**PPL Bell Bend, LLC**  
38 Bomboy Lane, Suite 2  
Berwick, PA 18603  
Tel. 570.802.8102 FAX 570.802.8119  
rrsgarro@ppiweb.com

**BELL BEND NUCLEAR POWER PLANT  
RESPONSE TO RAI No. 47  
BNP-2009-292      Docket No. 52-039**

Response to NRC Request for Additional Information No. 47  
Bell Bend Nuclear Power Plant

**Figure K-2: Bell Bend Link  
Node Analysis Network  
Inset 1**

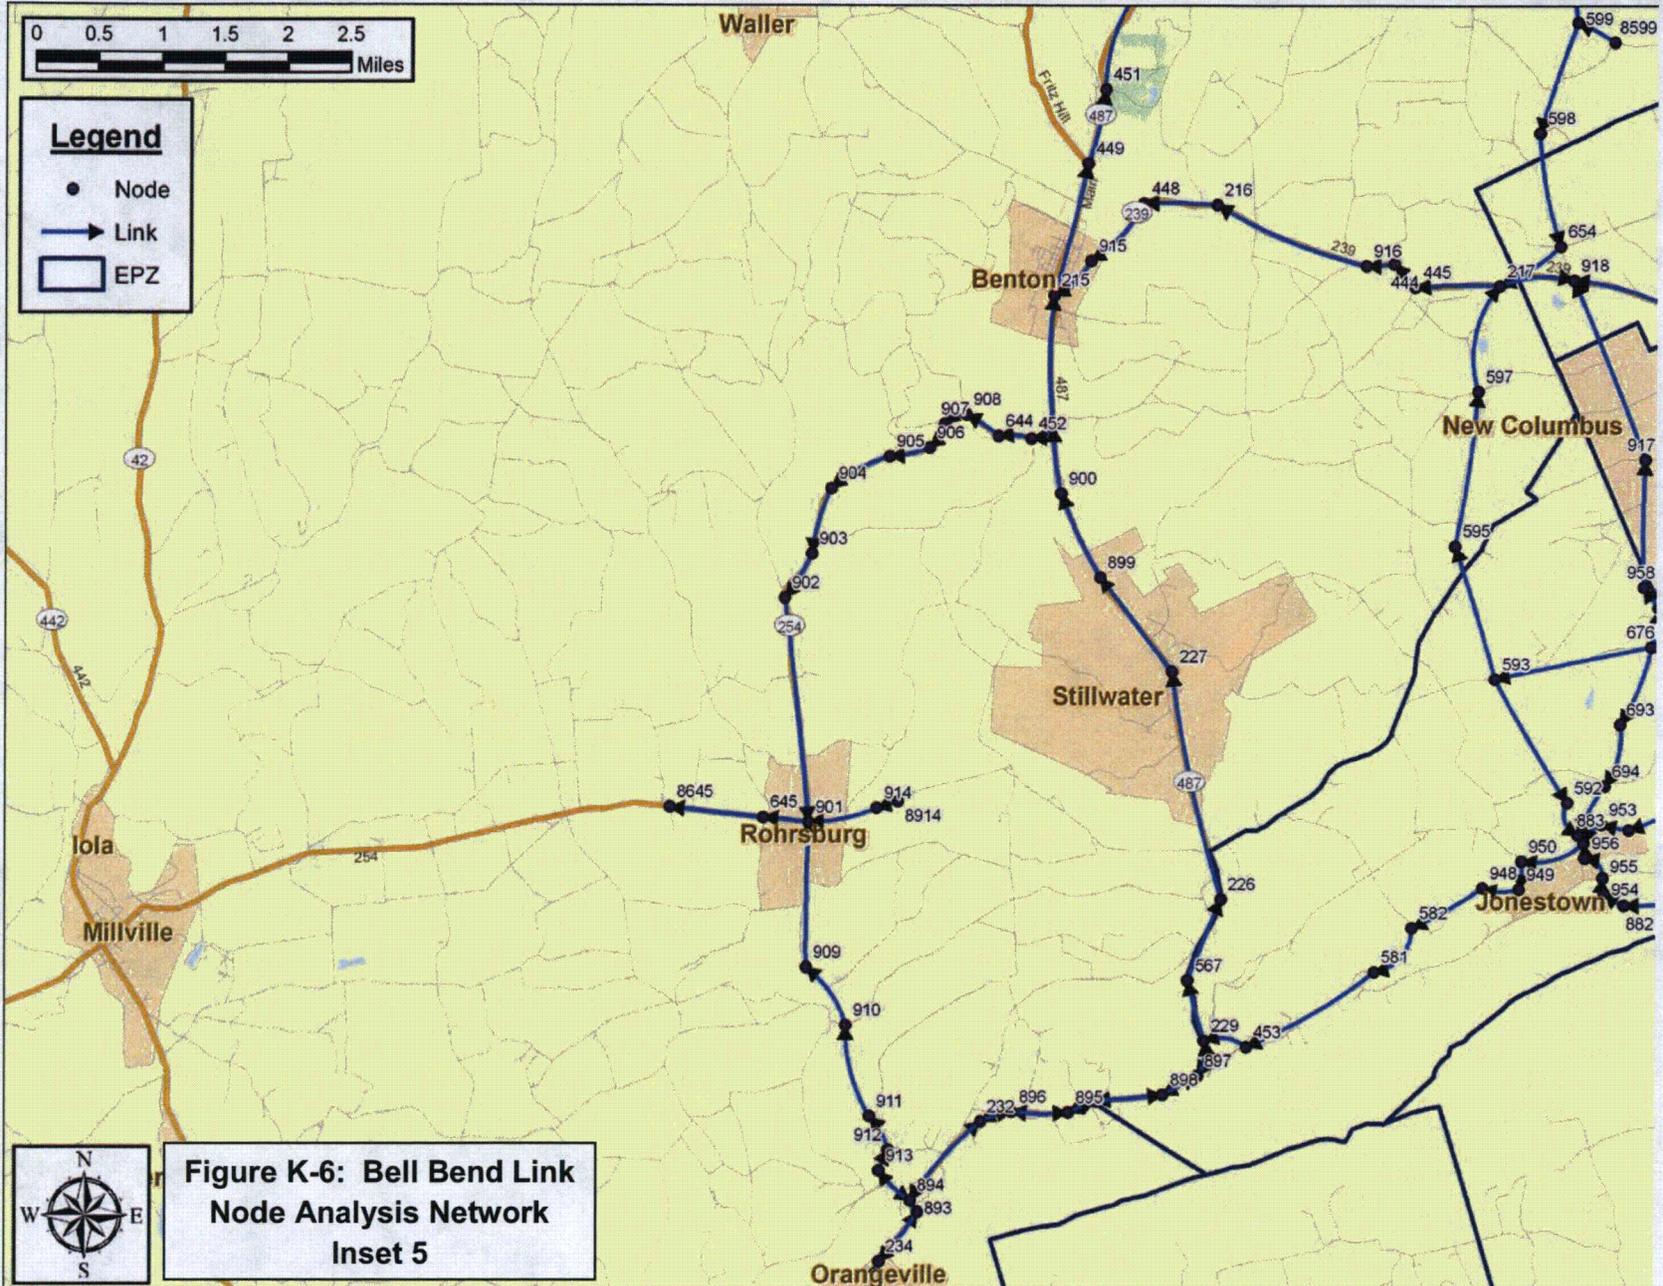
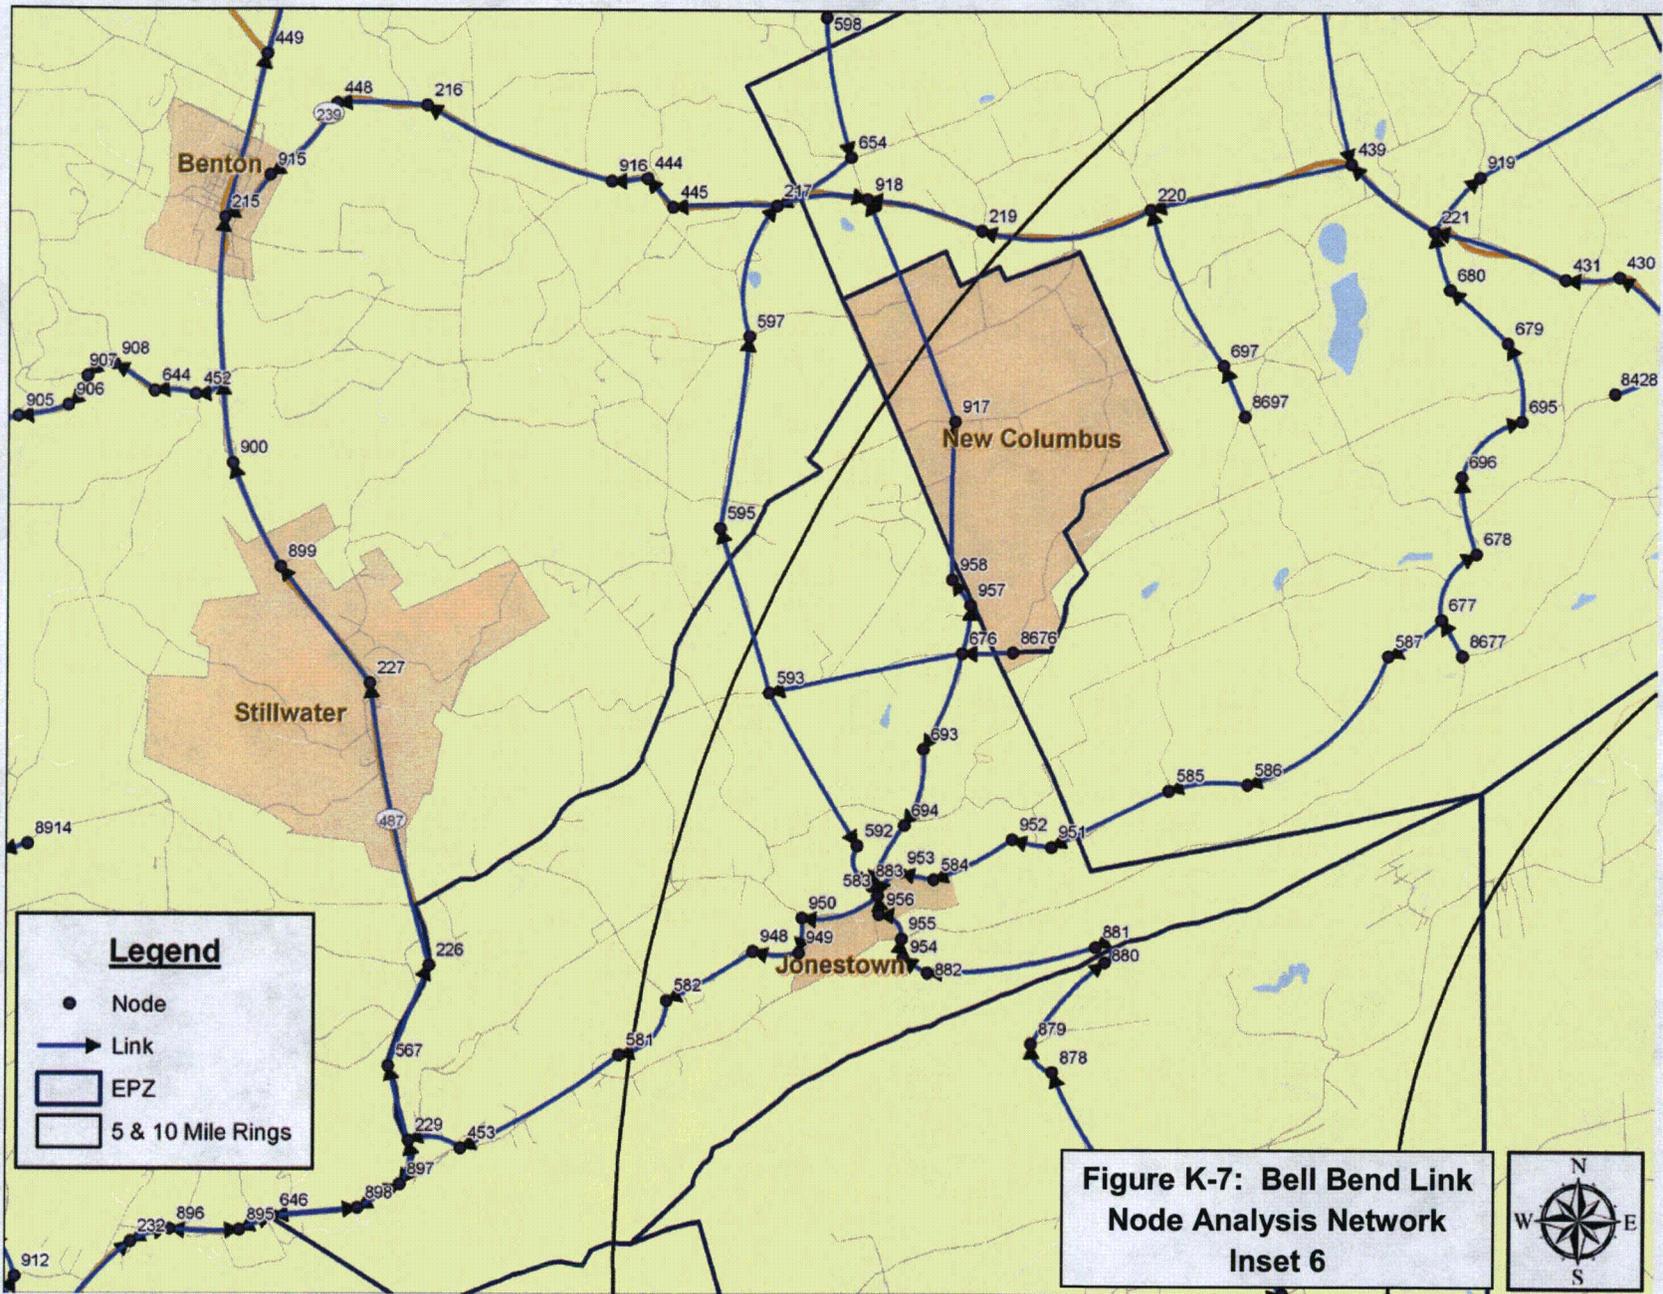
- A. Figure 1-2, "SSES/Bell Bend Link-Node Analysis Network," shows the nodes used in the analysis, but the nodes are not labeled to correspond to Appendix K, "Evacuation Roadway Network Characteristics." Provide a map in a revision to the ETE report that includes legible node numbers that correspond to Appendix K.

Due to the scale of Figure 1-2, the node labels and link directional arrows were removed for clarity. Figure 1-2 will be divided into several figures in Appendix K in a future revision of the ETE report, which will show the directional arrows and annotate the nodes within the link-node analysis network. The reference to Figure 1-2 in Section 1.3 will be revised to reference the newly added figures in Appendix K; these newly added figures are attached to this response.

As discussed in Section 1.3, a computerized link-node analysis network was constructed to model the evacuation roadway network within the study area. Figure K-1 provides an overview of the link-node analysis network. The figure has been divided up into 18 more detailed figures (Figures K-2 through K-19) which show each of the links and nodes in the network.
